D350-567-031
Job Sheet 184774

Part Name: Interior Window For -015 & -025

Note: DWG DSI9745-011 REV A, IIN-D350-567 REV E SHEET 28 IPP Rev:A new issue 08-04-25 DD verified by: LL
IPP Rev:B 08-10-07 as per revD DD verified by: IPP REV:C 13.10.15 AS PER IIN REV.E DD VERF:JLM IPP
REV:D 16.04.25 as per chg002 DD VERF:JLM

**DETAIL A**

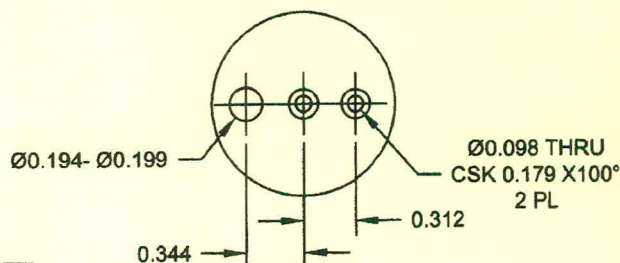
For customers with kits D350-567-013/-015/-017/-023/-025/-027/-117 @ CHG002 and earlier,
Customers with kits D350-567-111 @ CHG006 and earlier,
Customers with kits D350-567-115 @ CHG004 and earlier,
Customers with kits D350-567-031/-031B/-111B/-115B @ CHG001 and earlier,
Procure kit DSI 9745-011

For customers with kits D350-567-013/-015/-017/-023/-025/117 @ CHG003 and later,
Customers with kits D350-567-111 @ CHG007 and later,
Customers with kits D350-567-115 @ CHG005 and later,
Customers with kits D350-567-031/-031B/-111B/-115B @ CHG002 and later,
Refer to Installation Instructions D350-567 and ICA-D350-567 and update the parts list as follows:

EDIT 5.0 ADD:

Qty -013	Qty -023	Qty -113	Qty -115	Qty -031	Part Number	Description
X					D350-567-013	REPLACEMENT WINDOW KIT (SMALL)
	X				D350-567-023	REPLACEMENT WINDOW KIT (LARGE)
		X			D350-567-113	REPLACEMENT WINDOW KIT (EXTRA LARGE)
			X		D350-567-115	INTERIOR FLOOR WINDOW KIT
				X	D350-567-031	INTERIOR FLOOR WINDOW KIT (SLIDING DOOR COMPATABLE)
			1	1	D5420-1	DOUBLER PLATE
			4	4	AN3-4A	HEX HEAD BOLT
			8	8	MS20426AD3-5	CSK RIVET
			4	4	MS21062L3	NUTPLATE
